Agenda Item #5

Certified Record 2025-47-CA

360 Dauphin Street

Alterations to south facade

If Yes, a site plan showing all trees and landscaping that will be removed is required.

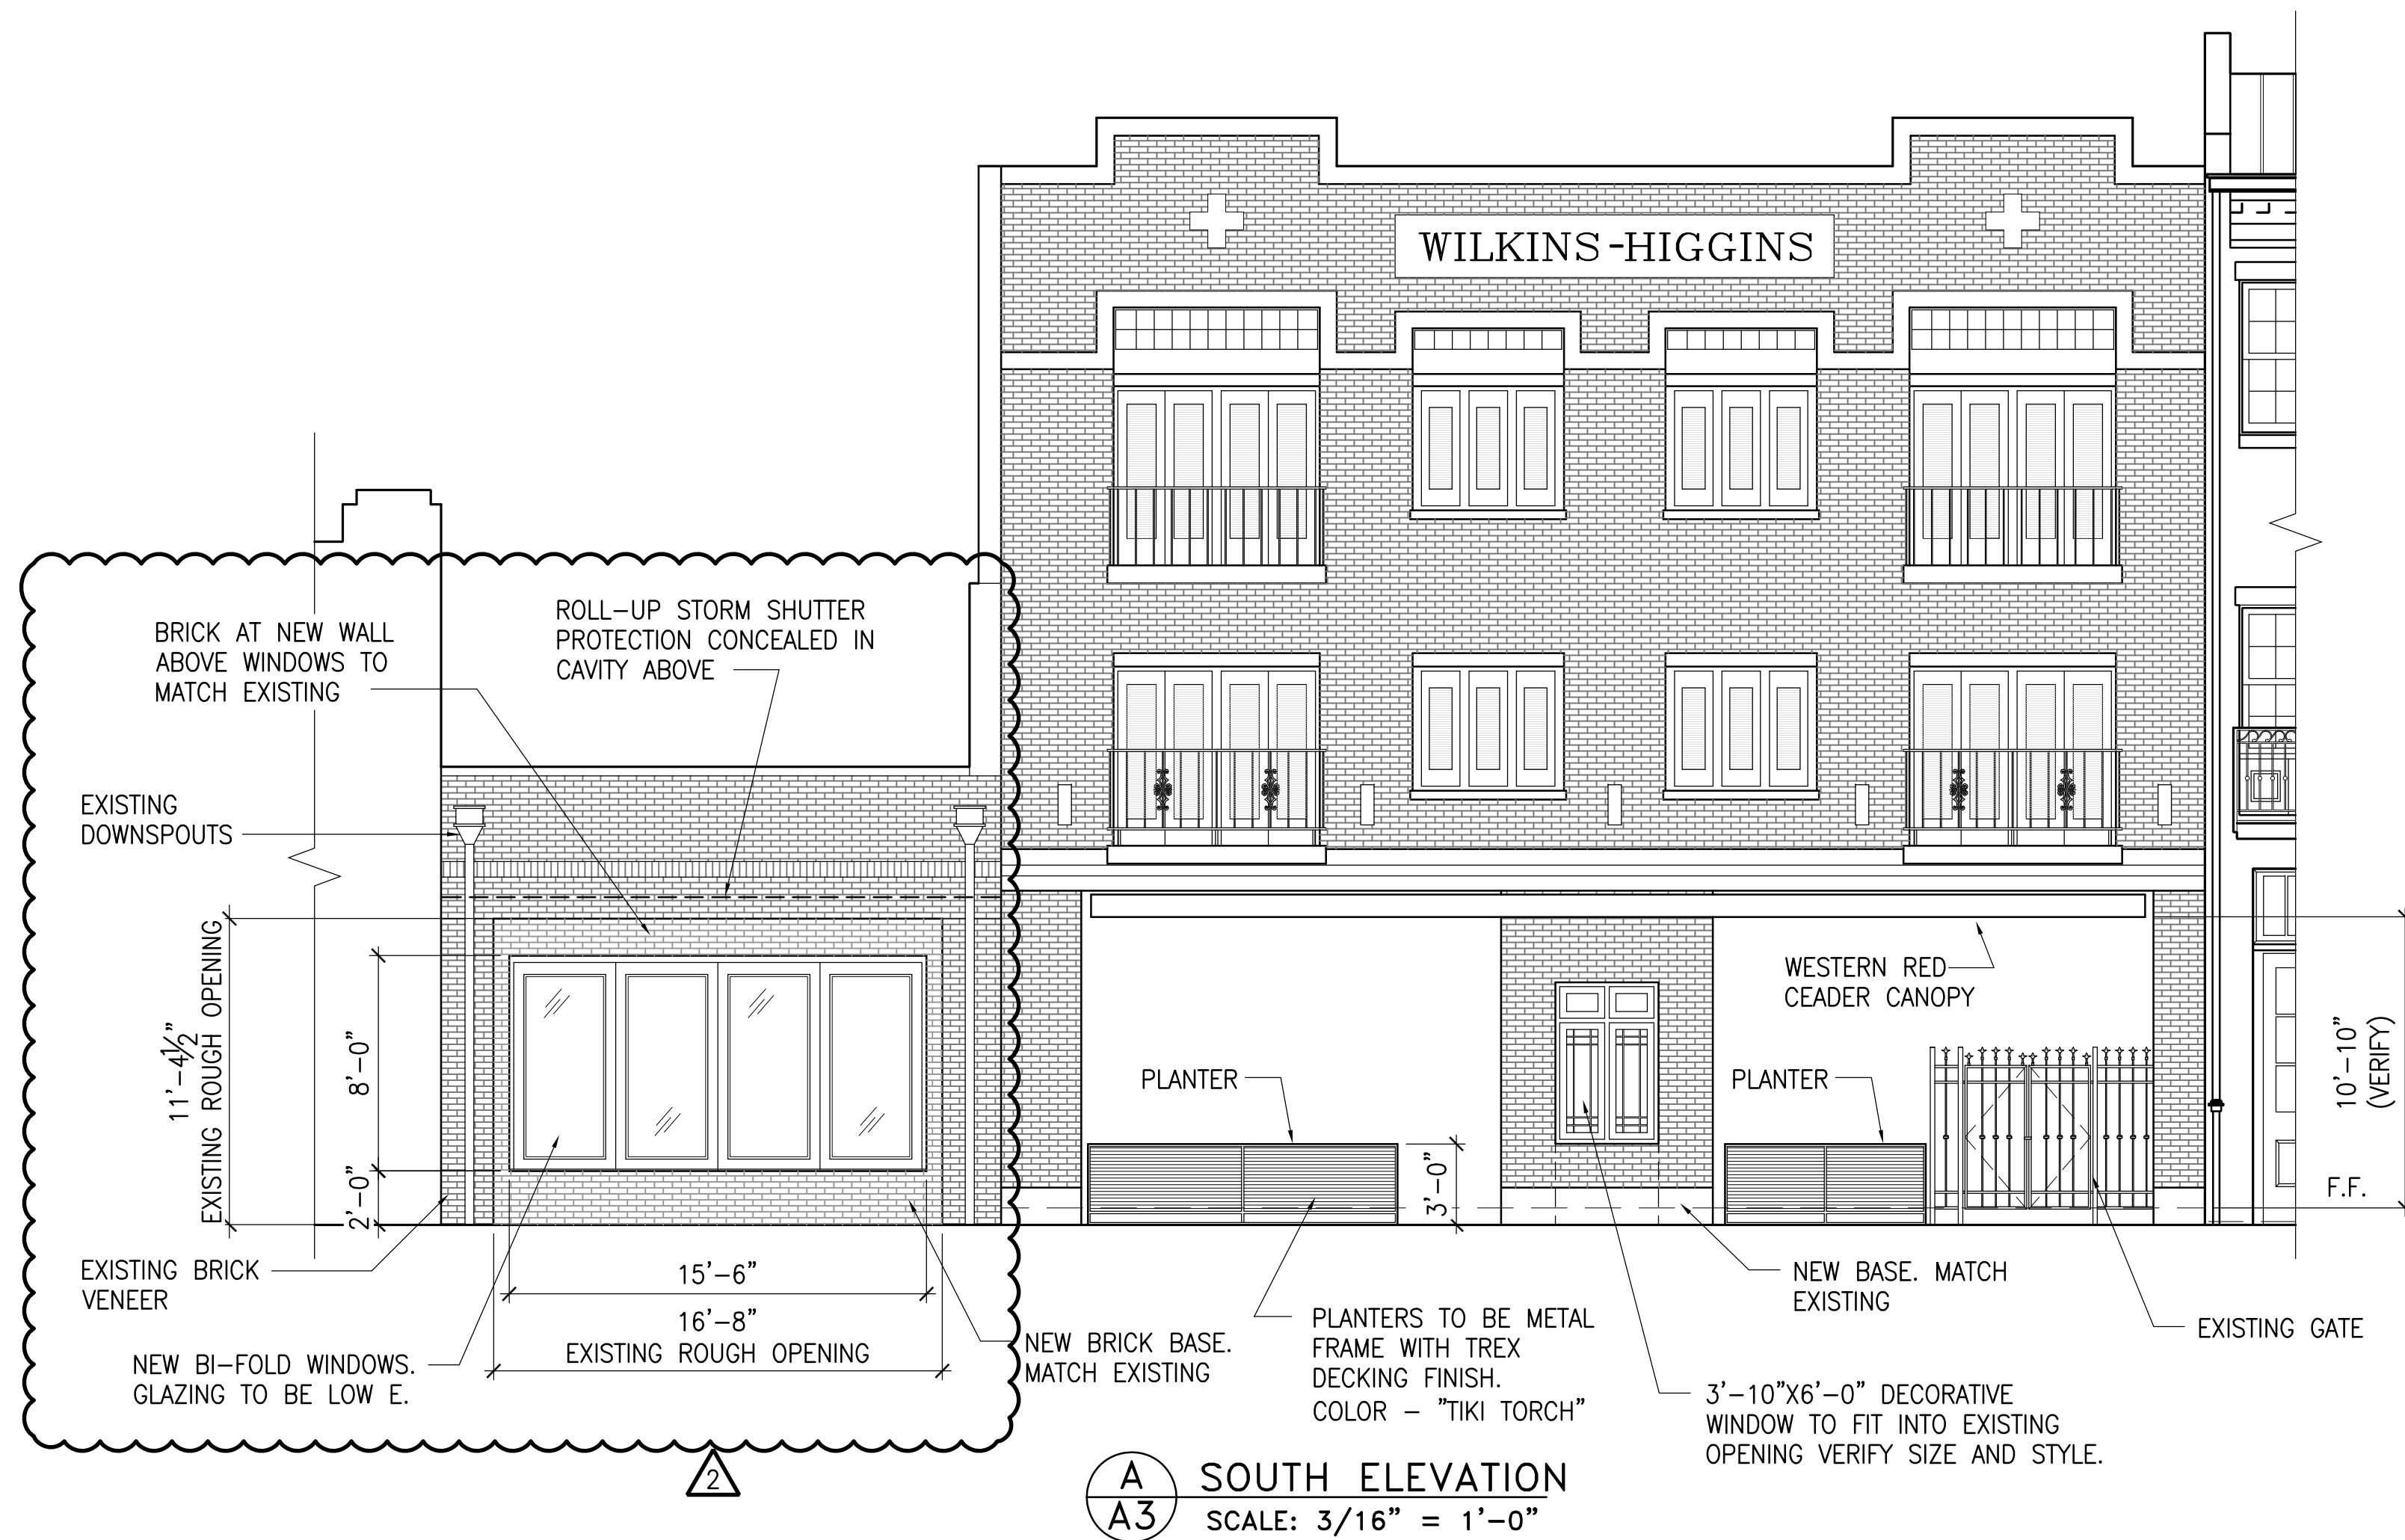
The proposed windows do lack an upper division to give the appearance of a transom. All other buildings on the block feature visible transoms above their storefront windows and/or entrance doors. Moreover, the Design Guidelines encourage including transoms in any new or replacement storefront design. A light divider across the top of the proposed windows roughly in line with the bottom of the transom glass at 362 Dauphin Street would blend better with the established fenestration pattern of the street. (7.18)

The application also proposes installing a low-e film on the windows. The Guidelines discourage the use of opaque window treatments, so any applied window films should maintain an appropriate level of transparency. (7.19)
